MEMO

To: Kristopher Byrd, Well Construction and Compliance Section Manager
From: Travis Kelly, Well Construction Compliance Coordinator
Subject: Review of Water Right Application G-19035
Date: February 9, 2022

Groundwater Application Review Summary Form

Application # G- 19035

D1. Well #: _____ Logid: _____

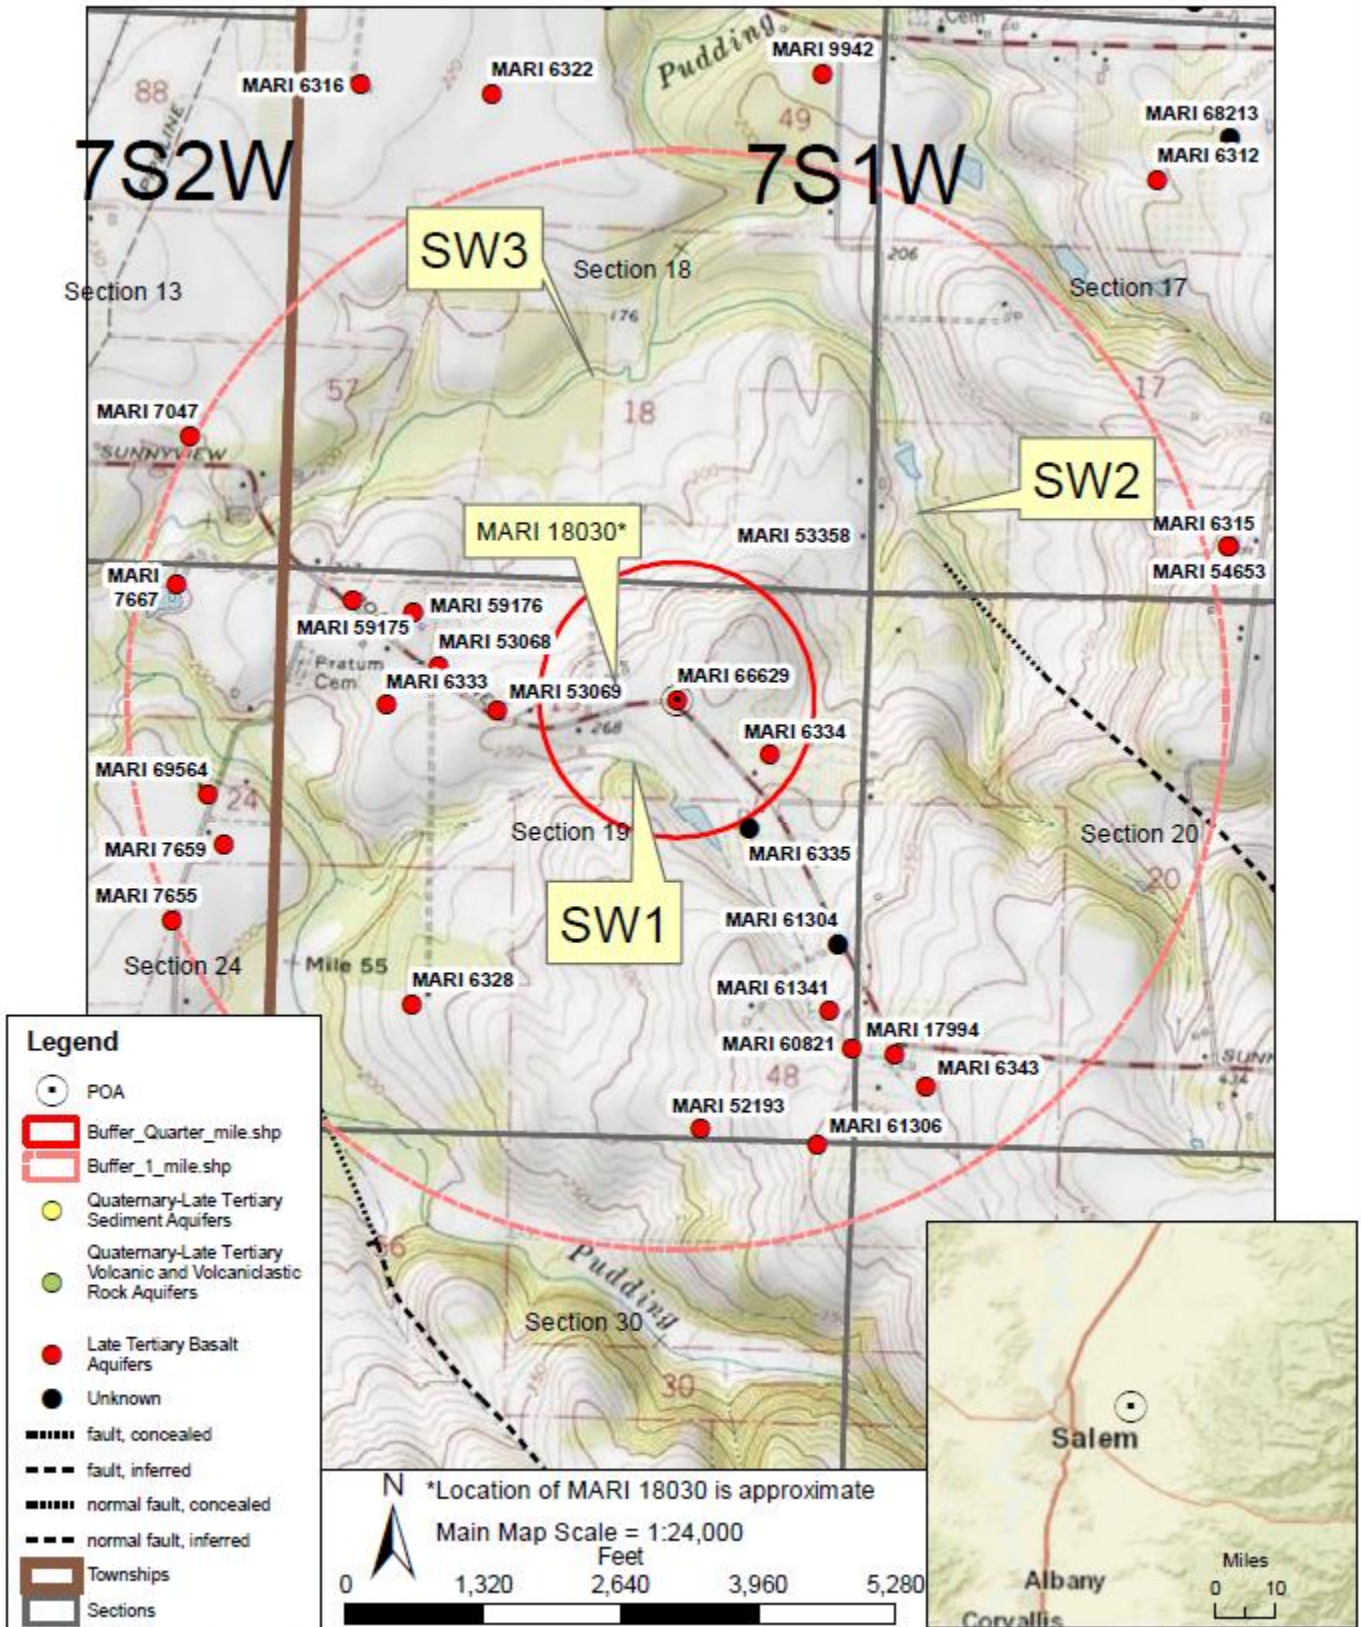
D2. **THE WELL does not appear to meet current well construction standards based upon:**

D3. **THE WELL construction deficiency or other comment is described as follows:** _____

D4. **Route to the Well Construction and Compliance Section for a review of existing well construction.**

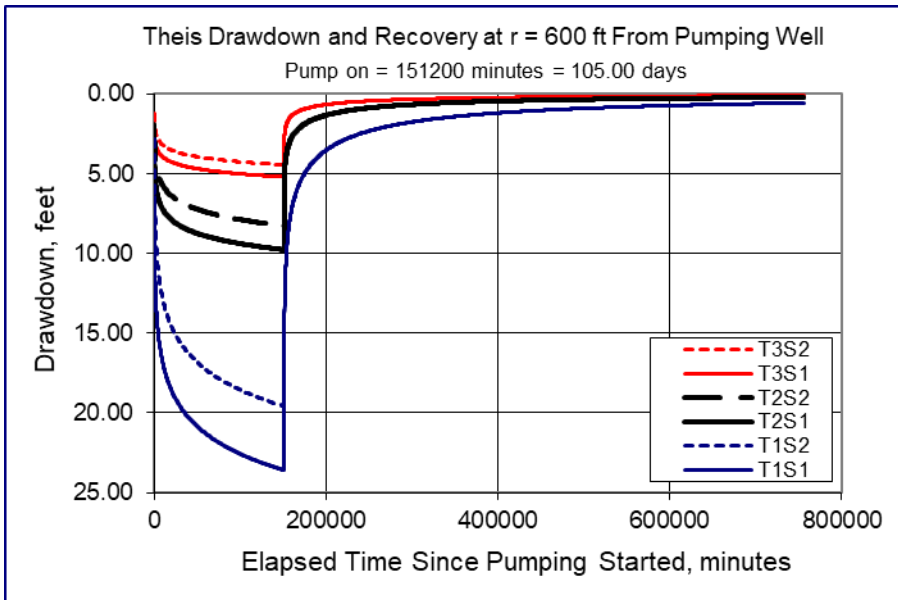
Radial distance from pumping well (r)=600 ft [estimated radial distance to nearest user, MARI 18030]

Pumping Rate (Q)= 0.708 cfs (317.75 gpm) [proposed rate]

Aquifer Transmissivity (T1)= 14,586 gpd/ft (1,950 ft²/day), (T2)= 38,896 gpd/ft (5,200 ft²/day), (T3)= 77,977 gpd/ft (10,424 ft²/day)

Storativity (s1) = 1 X 10⁻⁴, (s2) = 5 X 10⁻⁴ [Conlon et al 2005, Table 2 values for Central CRB]

Total pumping time = 105 days*

*The full pumping rate could not be utilized continuously for the entire 245-day irrigation season without exceeding the 147.75 ac-ft maximum allowed duty. For the maximum allowed duty of 147.75 ac-ft at 0.708 cfs, continuous pumping would occur for approximately 105 days.
